March 9, 2010

DOCKET
02-AFC-4C

**RE: REQUEST FOR STAFF APPROVED MODIFICATION: WALNUT ENERGY
CENTER AUTHORITY WALNUT ENERGY CENTER (02-AFC-4C):
INSTALLATION OF MICRO FILTER FEED TANK AND SHADE STRUCTURE**

DRAWING NO. IND5458

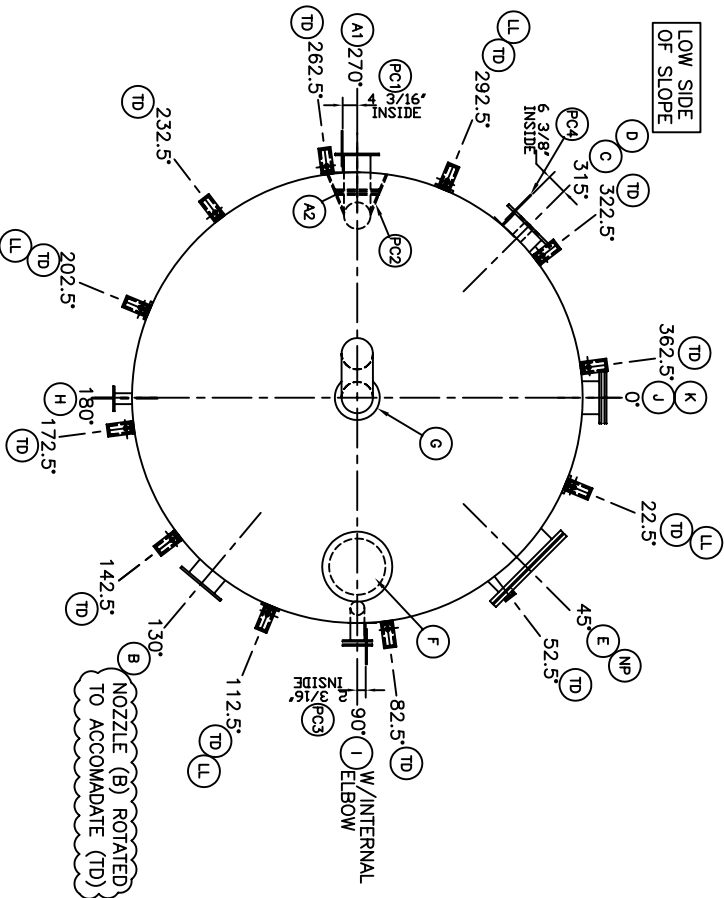
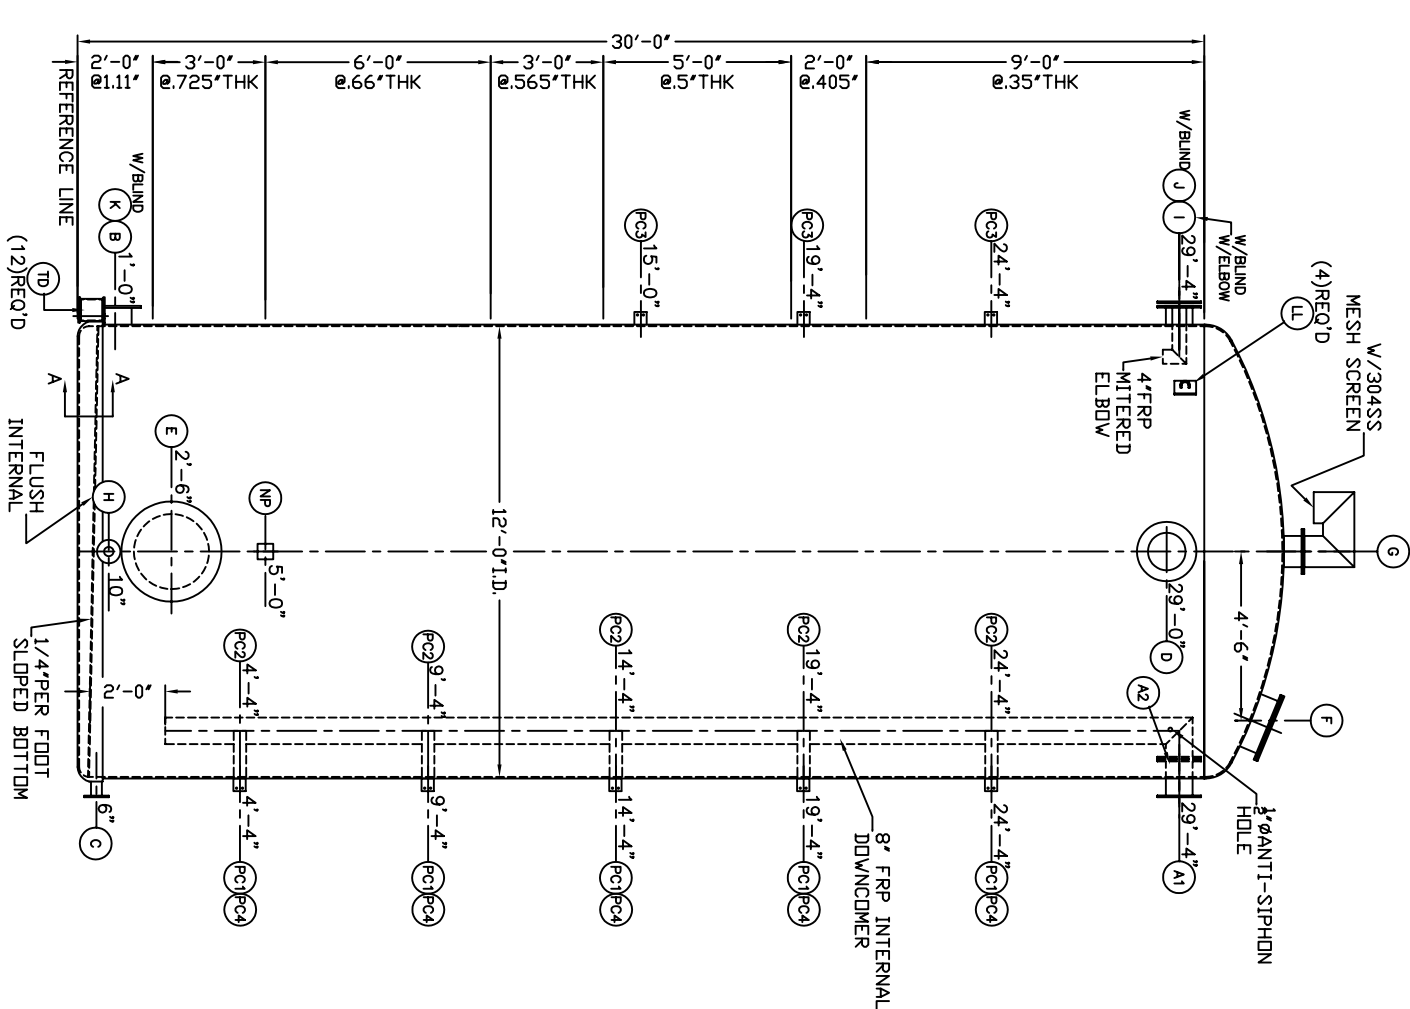
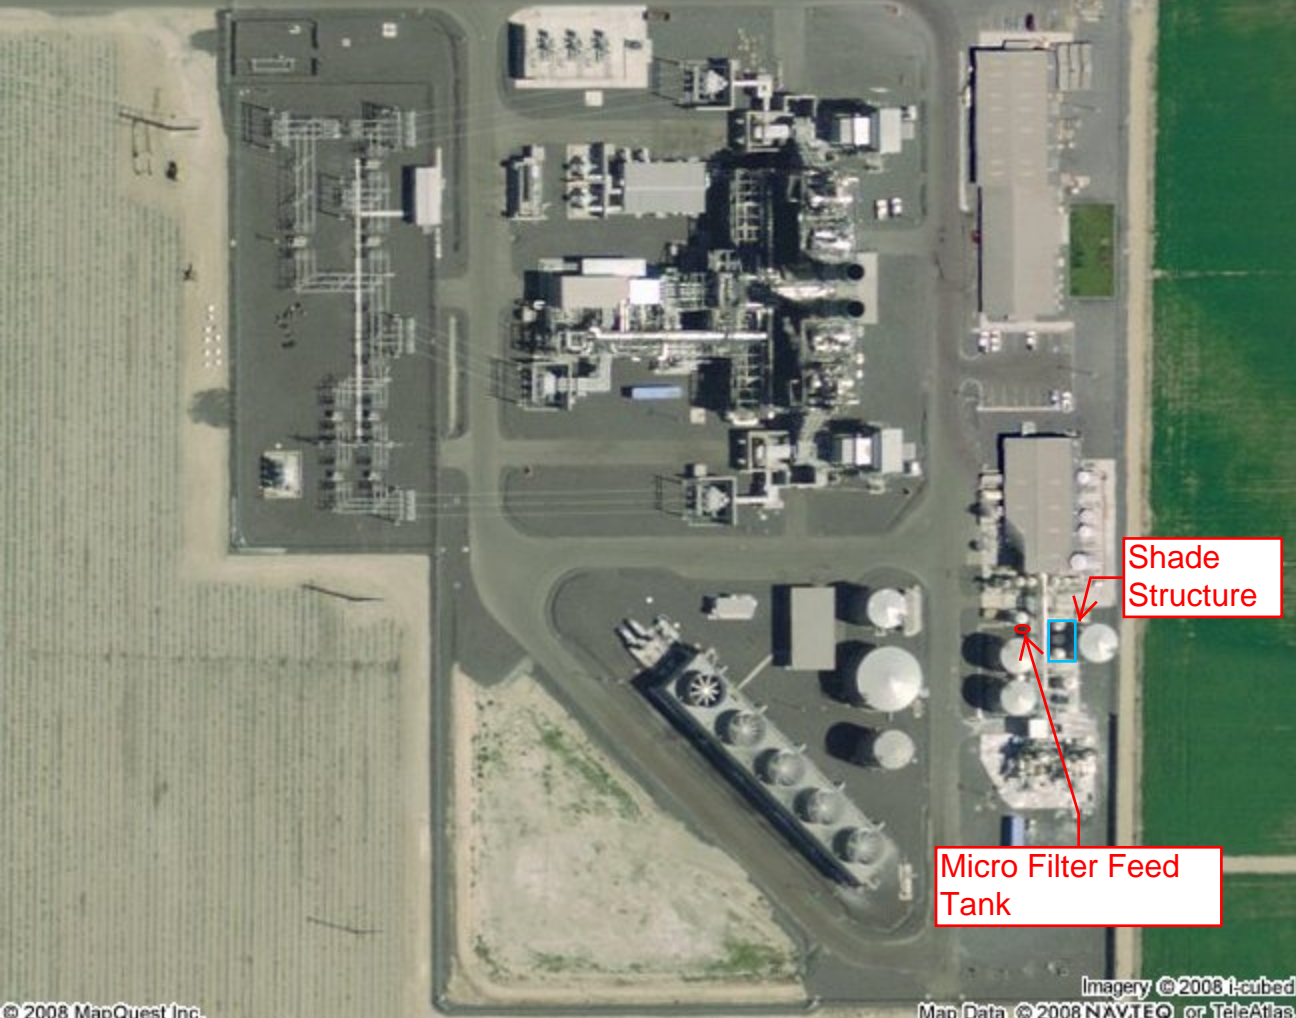
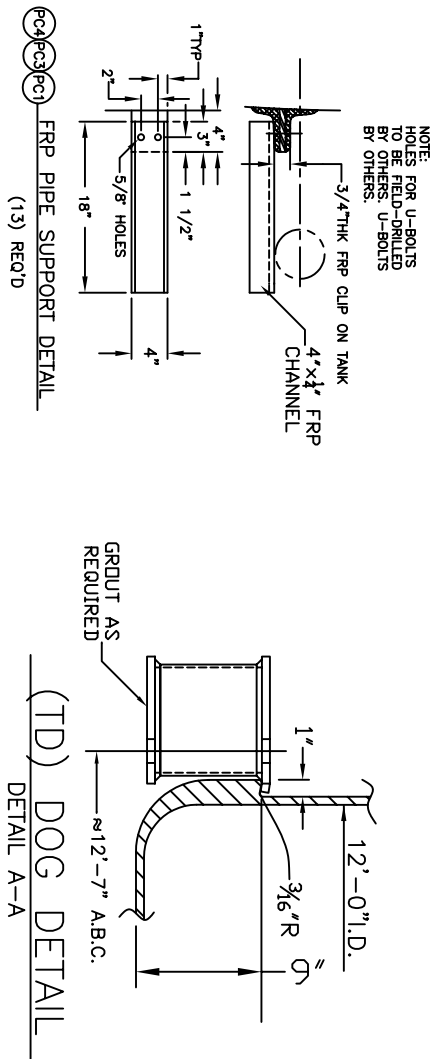
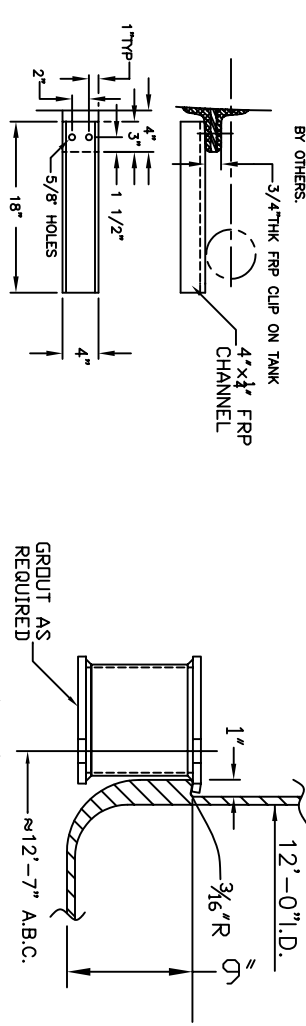
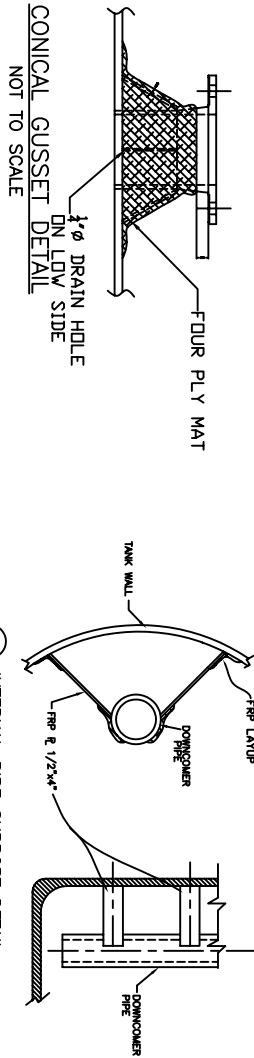
The Micro Filter Feed Tank is a 24,000 gallon fiberglass tank (12' diameter x 30' in height). It is gray in color, matching the other structures at the WEC, and is located in the ZLD water treatment process area. This new tank is not clearly visible from outside of the plant property. The Micro Filter Feed Tank was sized to meet the design requirements of the new micro filtration equipment and stores the cooling tower blowdown for use in the micro filters. The tank provides enough storage to handle brief upsets in the micro filters without affecting the cooling tower chemistry.

Included in Attachment 1, are three figures that depict where the tank is located and its dimensions. This first figure shows the new Micro Filter Feed Tank. The Micro Filter Feed Tank is approximately 2 feet shorter than the HERO Reject Storage Tank (on the right side in the picture). The second figure is a fabrication drawing of the Micro Filter Feed Tank that shows its dimensions. The third figure is an aerial of the WEC plant. The location of the new Micro Filter Feed Tank is shown on the figure.
